100/300 AREA UNIT MANAGER MEETING ATTENDANCE AND DISTRIBUTION

100 & 300 AREA UNIT MANAGER MEETING MINUTES

July 14, 2011

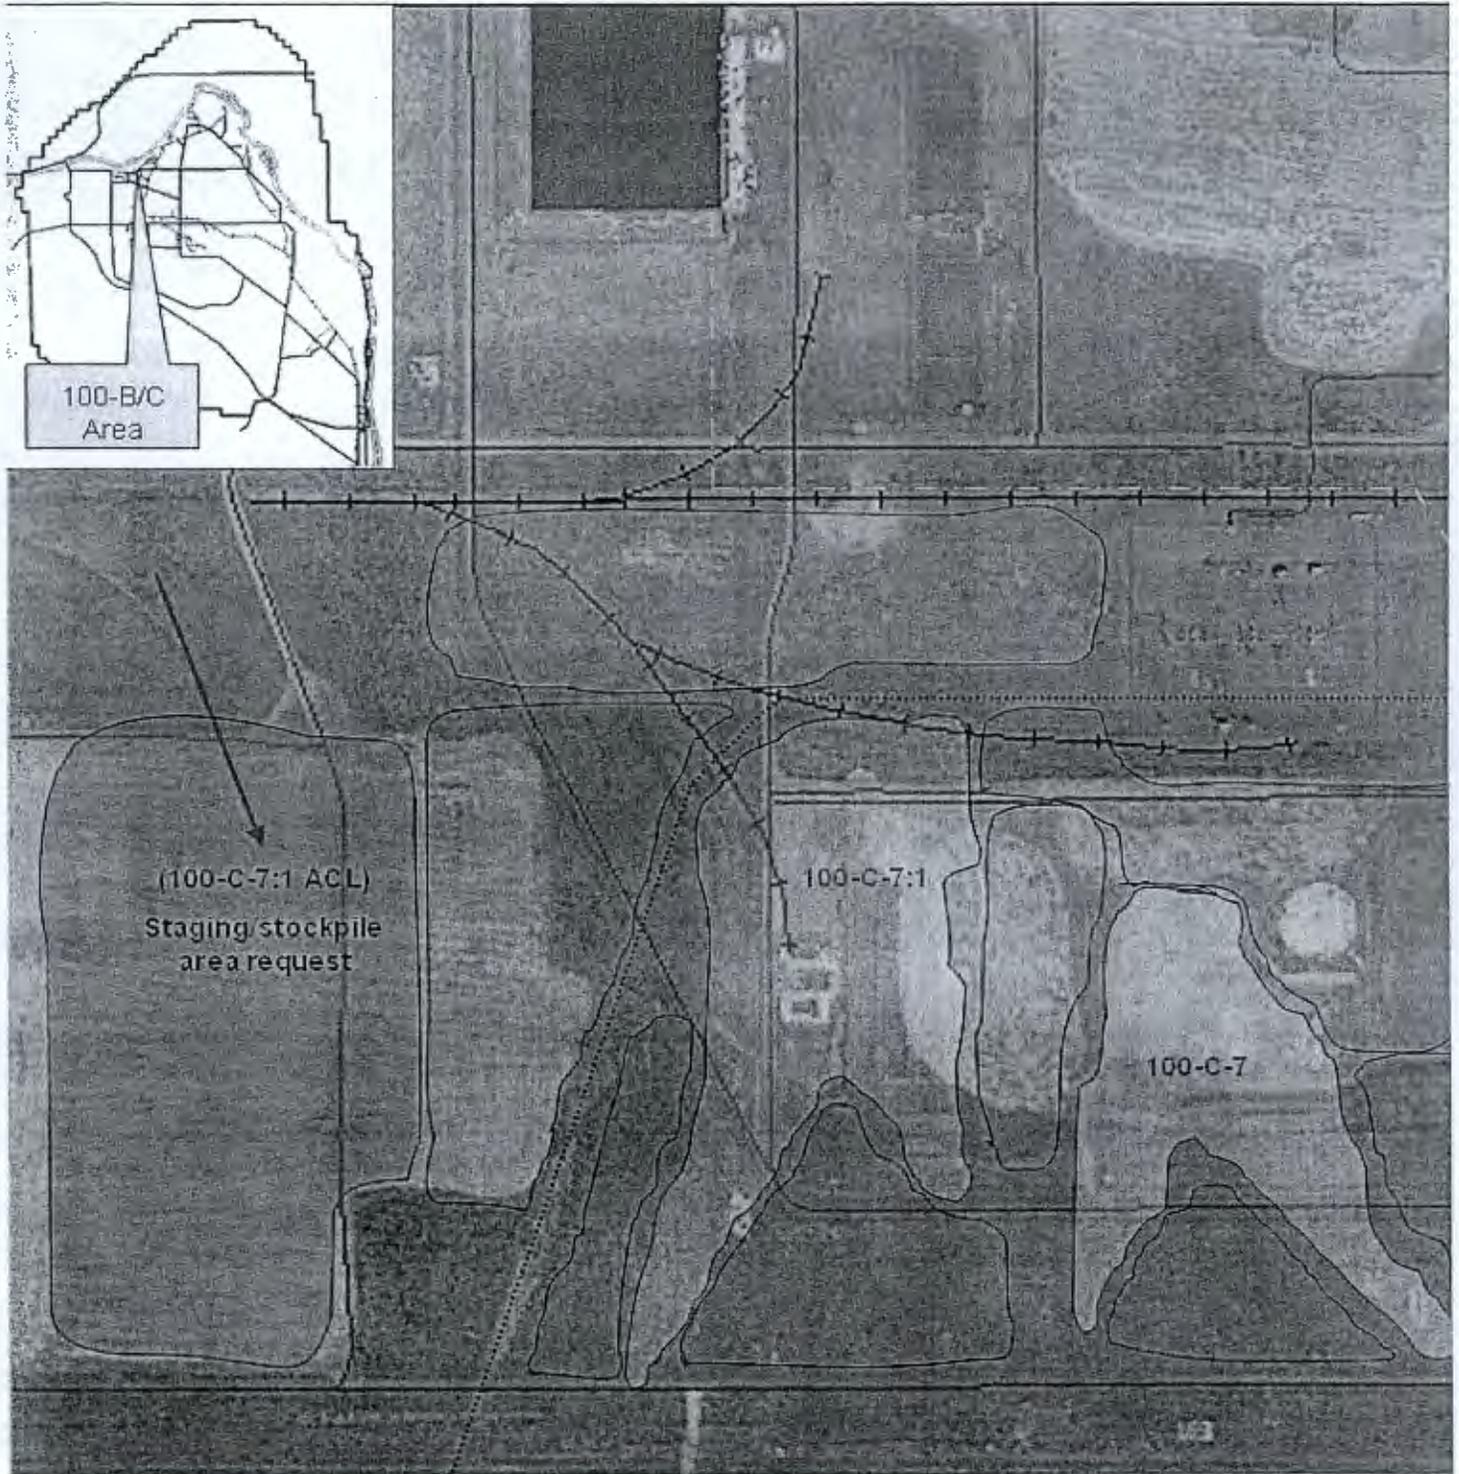
Hi Laura, we need to expand our staging area for waste coming out of 100-C-7:1. The map below depicts the area we'd like to add (lower left). Let me know if you concur, unfortunately, operations would like to start using the area soon.

Figure 1. 100-D/DR Area Overall Site Plan.

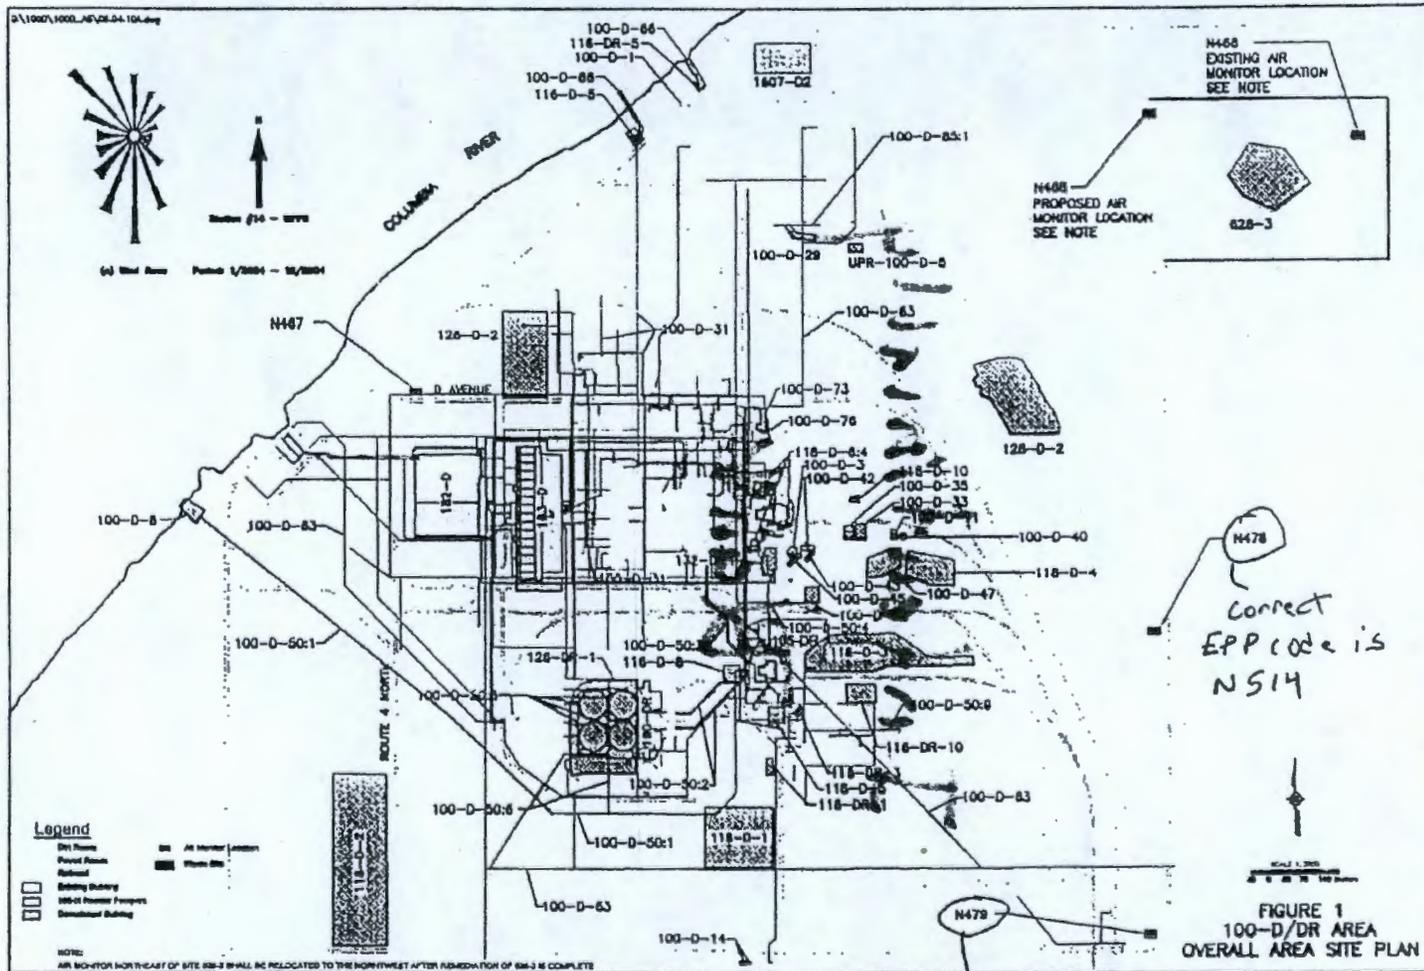
Kim, a typo was found on the 100-D air monitoring plan and I'd like to make sure Ecology is aware of it. The figure included in the plan (attached) contained the wrong air monitoring number (also called an EDP code) for monitors N514 and N515. They were erroneously listed as N478 and N479.

Correct EPP code is N514

The next time the 100-D air monitoring plan is revised, we'll ensure that the correct monitoring number, or EDP code, is listed in the plan.
